**Seattle-Tacoma International Airport
 Airport Dining & Retail Program Leasing
 Request for Proposals – RFP26-1 FB, SR, and CR All Packages Questions and Answers
 Question Set #1**

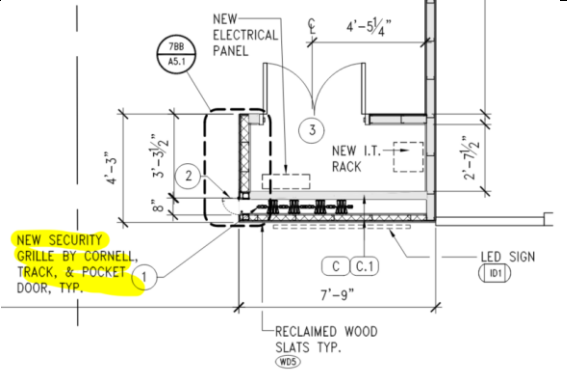
28	ALL	In the L&C Agreement there are highlighted yellow, green sections. Can you clarify what the highlighted green sections refer to specifically on pages 4, 7, 26 and 59?	The highlighted sections are for Port use to finalize the L&C Agreement with the Selected Proposers.
29	CR	For CA-02 there seems to be a discrepancy in the LOD size. In the meetings notes the LOD is shown in RED expanding right to the column A22, however in the RFP the LOD (shown in blue) stops in between A22 and A23. Please advise.	Proposers should use the LOD provided in the Tenant Handbook.

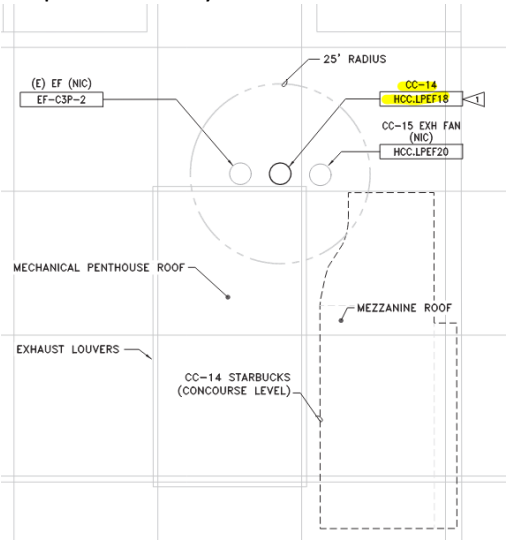
215	FB	For each of CA-08, CC-14, and CT-19, will the Port confirm whether the existing operator's improvements (millwork, equipment, finishes, MEP) will be removed prior to turnover, or whether the space will be delivered with existing improvements in place that the Selected Proposer must demolish at its own cost?	The TASC project will demo all millwork, equipment, finishes, etc. The existing tenant will be responsible for removing loose equipment and furniture before the TASC project begins construction. Bidders of this RFP should expect a "cold shell".
216	ALL	Section 7.1 states that the Port "to the greatest extent possible" will provide shell conditions including demising walls, slab, unfinished ceiling, and utility tie-in locations. For each of CA-08, CC-14, and CT-19, will the Port specify the actual	Proposers should review the Tenant Playbook for the turnover condition of these spaces.

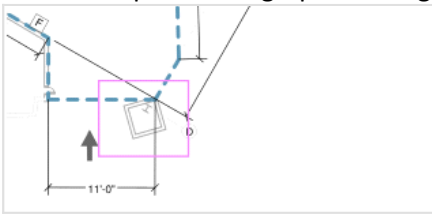
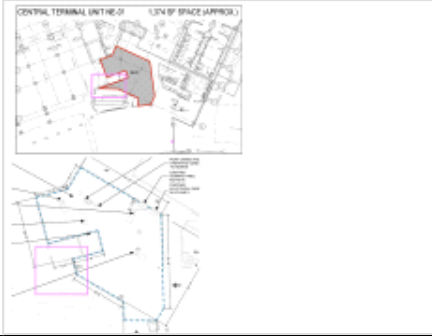
231	ALL	Section 7.1 references 7.3 but there is no section 7.3	The is no Section 7.3 please disregard.
232	ALL	Section 10.3 references a “black entry portal” -- please clarify what this is referring to.	There is no black entry portal, please disregard.
233	CR	For space CT-19, is it possible to cover the Central Terminal column with our finishes to allow the ceiling and signage elements to algin with the column?	If the Proposer is successful, this will require further conversation with ADR and the F&I architectural stakeholders.
234	FB	In a coffee concept, King county Department of health does not require a dish machine. Will the port allow for just a three comp sink and no dish machine in a coffee concept?	See response to question 94.
235	FB	Where is the pre-existing Type 2 shaft on the drawings for CC-14	<p>Approximate location below. Selected Proposer to verify:</p>

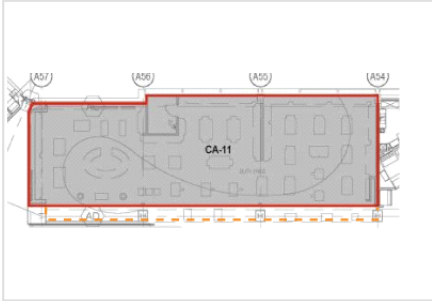
251	CR	CC-12 Can the airport please provide the "Tenant ADR Shell and Core Renovation (TASCR) Tenant Handbook" page for this space like others provided?	See Appendix A
252	CR	NE-01 Will the airport allow graphics or signage on this column? (indicated in pink) 	ADR will work with the Selected Proposer on this request.
253	CR	NE-01 The LOD in the presentation slide show a different outline than the RFP, please clarify. (Indicated in pink) 	Please use the drawing provided in the Tenant Playbook.
254	CR	NE-01 Is there a closure grille in this space? (Indicated in pink)	All grills will be demo's as part of the TASCR project. Selected Proposer will need to design a new grill.

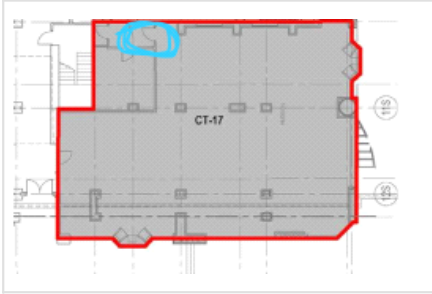
255	CR	<p>CT-17</p> <p>Can this side of the LOD be opened up (wall removed to increase visibility)? (Indicated in blue)</p>	The current LOD needs to be maintained for the purpose of this RFP solicitation.
256	CR	<p>CT-17</p> <p>Is the brown tile above the storefront a base building or tenant finish?</p>	Confirmed. This tile is a base building finish.

Question 62 and 251: Tenant Playbook Drawing for CC-12
There is no drawing for CA-11

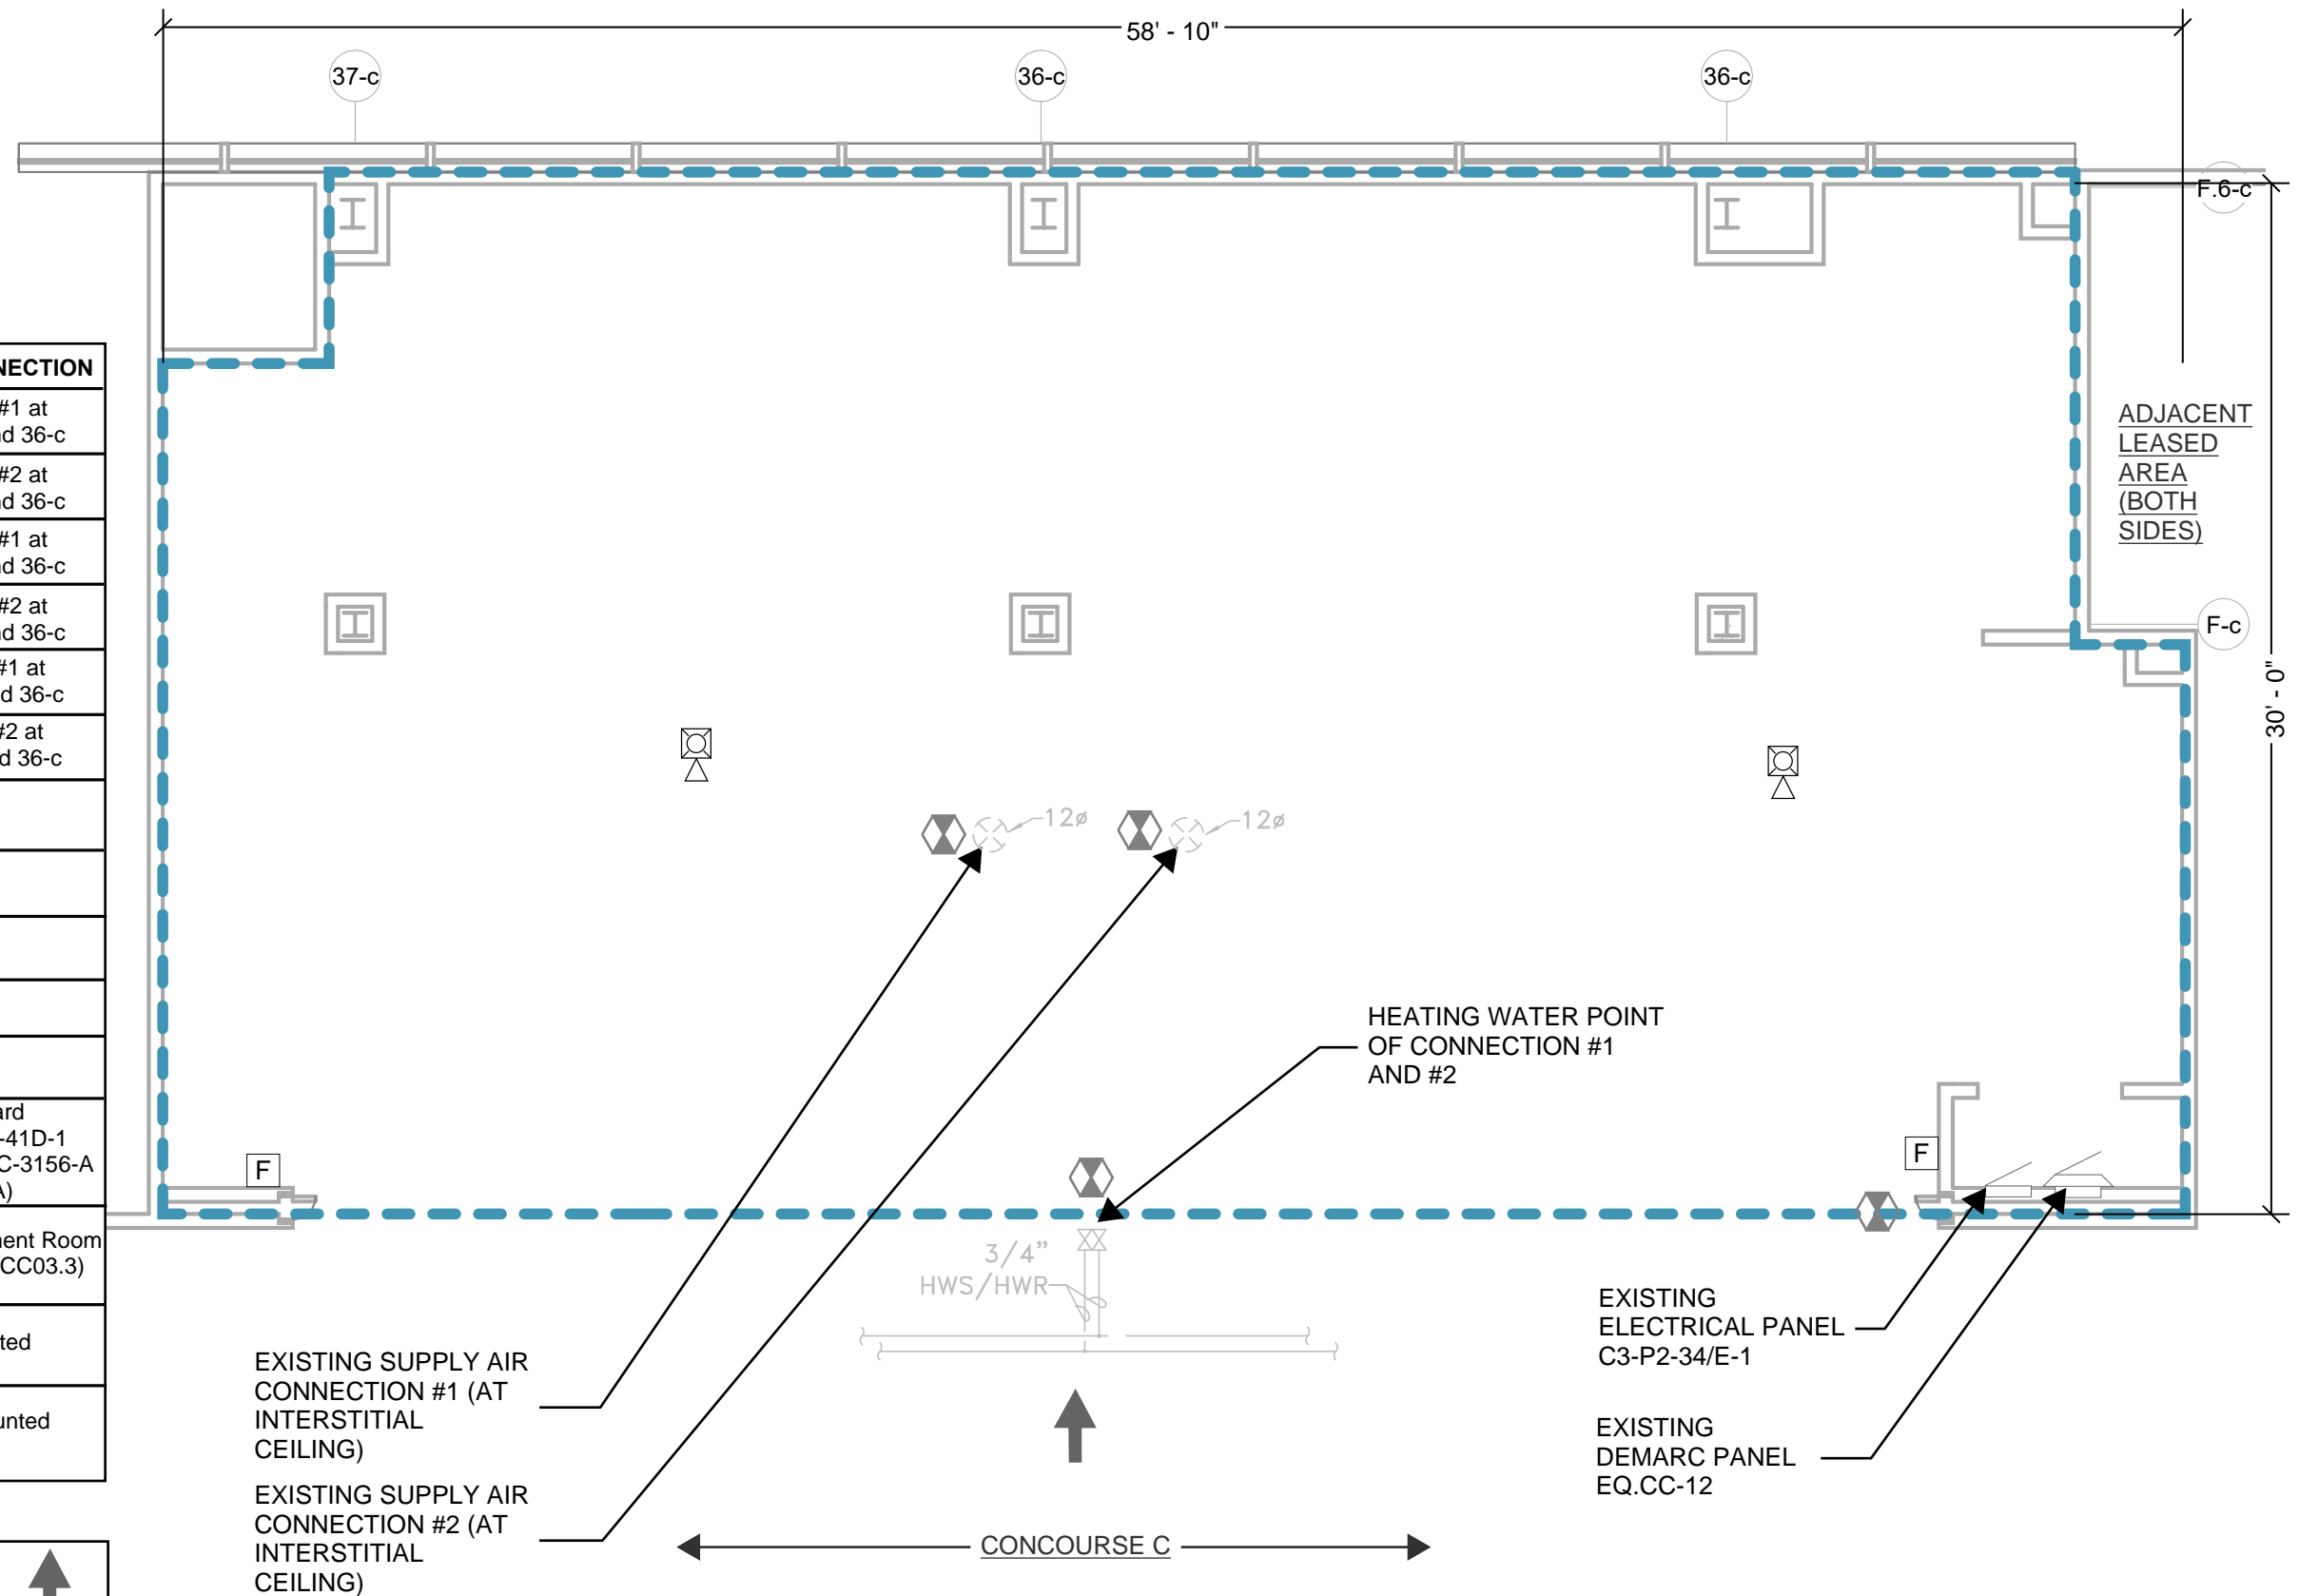
62	CR	I wanted to point out that a couple of units are missing Exhibit 2s in the Tenant Handbook. Let me know if you want me to submit this as a formal question. Missing in Exhibit 2 Tenant Handbook: CC-12 (package CR-1) CA-11 (package CR-2)	See Appendix A
63	ALL	Are you able to provide the range for sales per square feet for the different types of F&B retailer? This information will be helpful in our planning and projection efforts, allowing us to better align our assumptions with current market performance	Average sale per square foot per year for: Coffee: \$3,000.00 Specialty Retail: \$1,400.00 Convenience Retail: \$5,000.00
64	FB	For the coffee locations, it says no cooking of food is allowed, but is reheating food allowed to offer a greater variety of options for passengers and airport employees?	See Appendix A
65	ALL	Please confirm whether covers and tabs are to be counted toward the 200-page maximum for the proposal submission, or whether they may be excluded from that limit.	See response to question 19.

Question 64

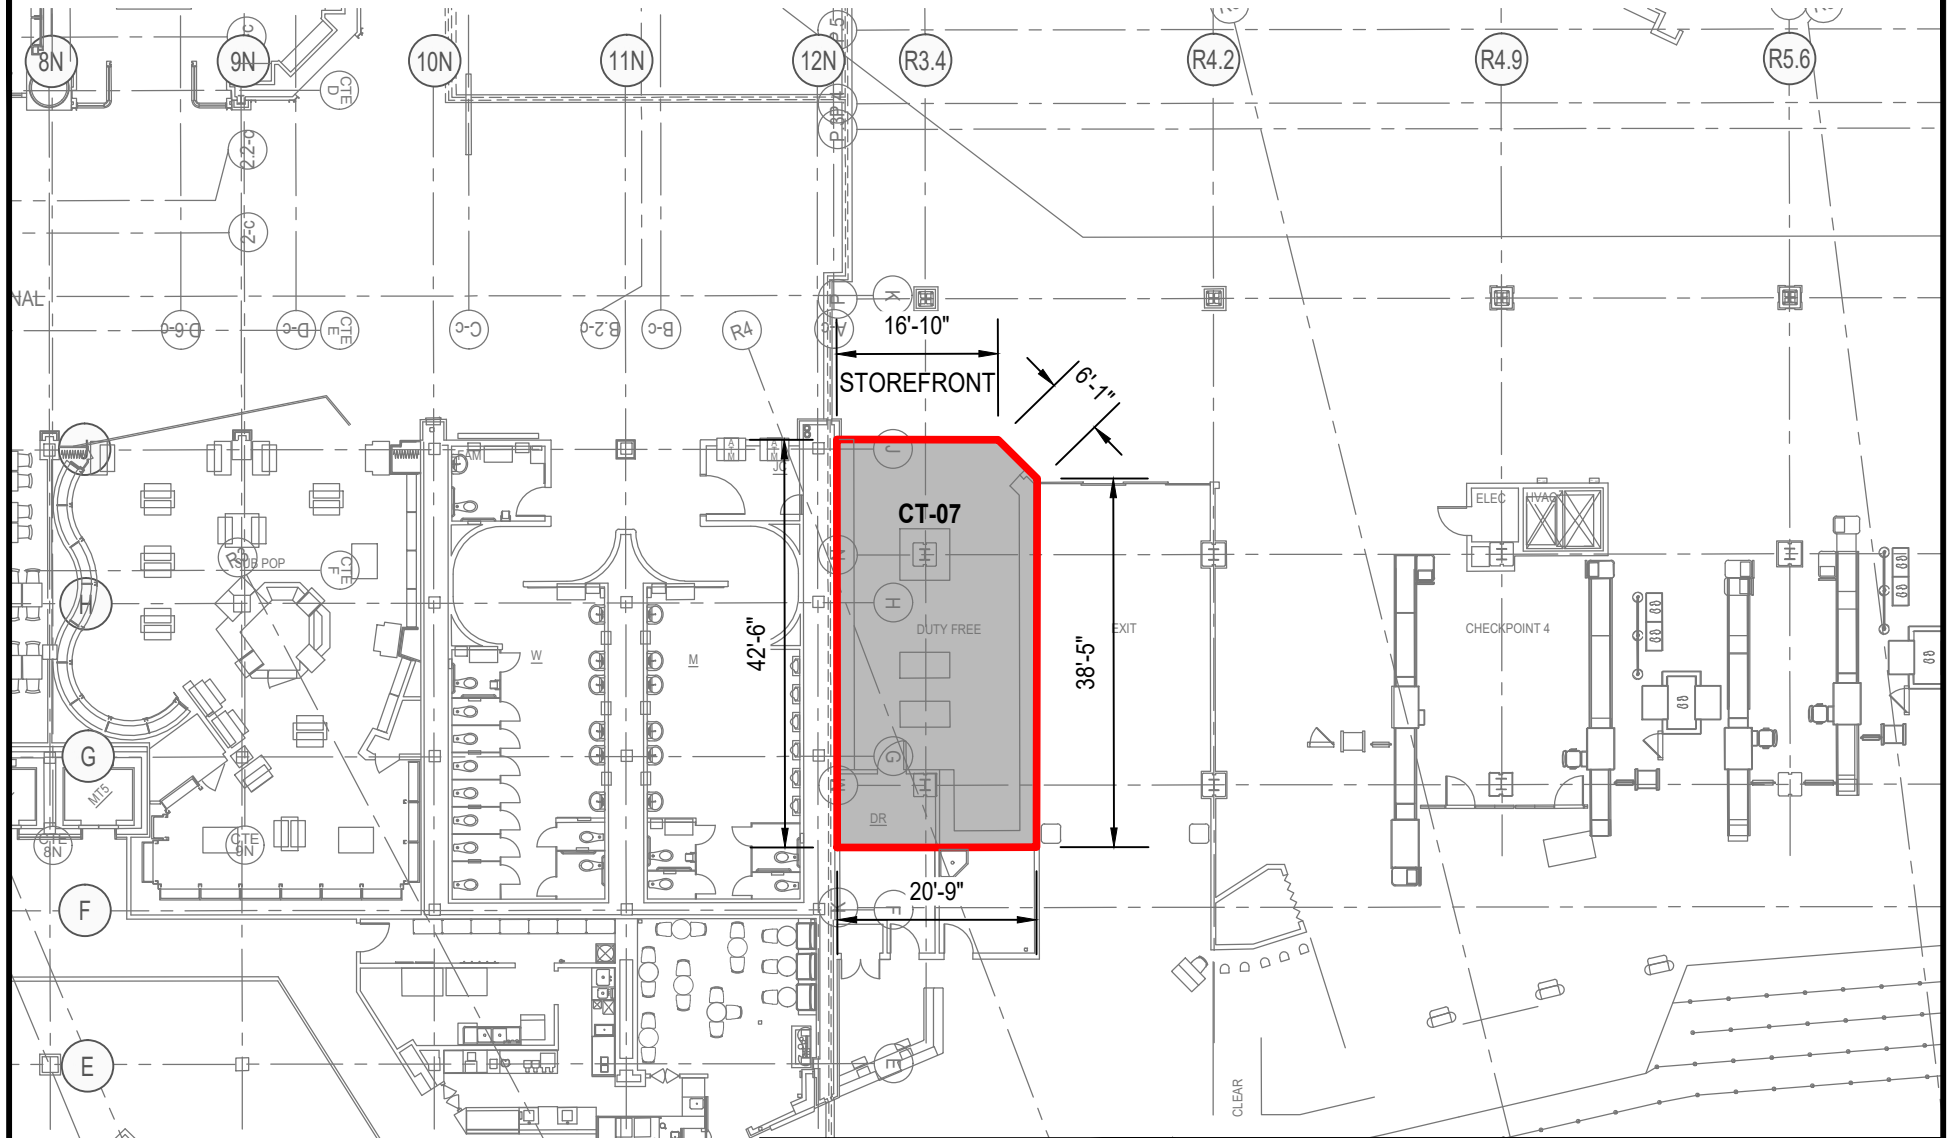
114	FB	For Space CC-14, please confirm that the POS does not require turbo chefs to utilize a Type 2 hood.	See response to question 64.
115	FB	For Space CC-14, please confirm a standard refrigerator with an internal evaporator pan is allowed in the no-go plumbing zone.	Plumbing penetrations in no go zone are permitted. If the refrigerator requires no penetrations in the slab, it should be acceptable.
116	FB	For Space CC-14, can plumbing from a 3-comp sink be routed over (not through) the floor slab in the no-go plumbing zone to an area outside of it.	Plumbing penetrations in no go zone are permitted. If the 3 comp sink requires no penetrations in the slab, it should be acceptable.
117	FB	For Space CC-14, what is the height of the space to the underside of the ceiling structure?	Existing ceiling height is approximately 9'-7". Selected Proposers will be given As-Builts.
118	FB	For Space CC-14, will we be allowed to maintain the existing slab penetrations and re-use them if desired?	No. All existing penetrations will be removed and patched back by the TASCRC project.

236	FB	Do you require a type 2 hood over a turbo-chef?	See response to question 64.
237	ALL	In section 10.1.9 do you want balance sheets and financial statements for only the company proposing or for all companies with the same ownership?	Only the company Proposing unless it is a Joint Venture then all partners.
238	ALL	Is a personal net worth statement required or suggested for companies that are not newly formed and have existing financial statements	The personal net worth statements are only for newly formed companies.
239	ALL	10.4.2 asks for “a completed financial Pro Forma for each individual unit, as well as for the entire package.” Should this Pro Forma only be completed for each individual unit that we (the proposer) are bidding on? Or are you looking for us to complete a Pro Forma for every single unit and the entire package of units regardless of what we are bidding on?	We are requesting for each unit and if a package has multiple units in it then each unit and the whole package.

Dishwasher		X			Chemical dishwashers are not allowed. Rinse temperature for dishwasher must be 140° F minimum per the health department.
Glasswasher, Undercounter			X	O	General HVAC is acceptable if the designer captures the heat and moisture load within the ventilation load for the space
Electric Range	X				
Fry Dump	X				
Fryer	X				
Gas or Open Flame Equipment	X				
Griddle	X				
Microwave (non retail)			X	O	Microwave shall only be used to warm/reheat food. In a non-commercial application, such as a break room or other tenant space for employee use, a limit of 3 microwaves shall be allowed with general HVAC. More than 3 microwaves in a space will require targeted exhaust.
Microwave (commercial use)			X		All ADR & Tenant spaces to be considered commercial use. Microwave shall only be used to warm/reheat food.
Panini Grill	X	O			Exhaust duct to be welded liquid tight, type 304 or 316 stainless steel.

Pasta Cooker		X			
Pizza Oven	X	O			Exhaust duct to be welded liquid tight, type 304 or 316 stainless steel.
Pressure Cooker		X			
Rice Cooker		X			
Rotisserie	X				
Salamander	X				
Toaster, Drop-in Slice			X	O	In a non-commercial application, such as a break room or other tenant space for employee use, a limit of 3 drop toasters shall be allowed with general HVAC. More than 3 toasters in a space will require targeted exhaust.
Solid Fuel Equipment	X				
Soup Warmer			X		Max temperature 205° F
Steam Table		X			
Steamer		X			
Warming Table (Dry/No Steam)			X

Toaster Oven			X	O	General HVAC may be approved for use in non-commercial application, such as a break room or other tenant space for employee use. 600 Watt or less
Waffle Iron			X		
Wok	X				
Rapid Cook Ovens	X		O		Rapid cook ovens, such as "Turbochef" products, shall be provided with targeted exhaust if only used to warm foods. If intent is to cook items within the oven, a Type I hood shall be required. Equipment data sheets as well as proposed menu shall be submitted to POS during design development for review.
Other Commercial Cooking Appliances	X	O	O	O	If tenant proposes to use a piece of equipment not listed above they should submit equipment data sheets and a proposed menu during design development . POS shall determine whether a Type I, Type II, or Targeted Exhaust is required based on POS standards and relevant codes.
Other Residential Cooking Appliances	X	O	O	O	If tenant proposes to use a piece of equipment not listed above they should submit equipment data sheets and a proposed menu during design development . POS shall determine whether a Type I, Type II, or Targeted Exhaust is required based on POS standards and relevant codes.
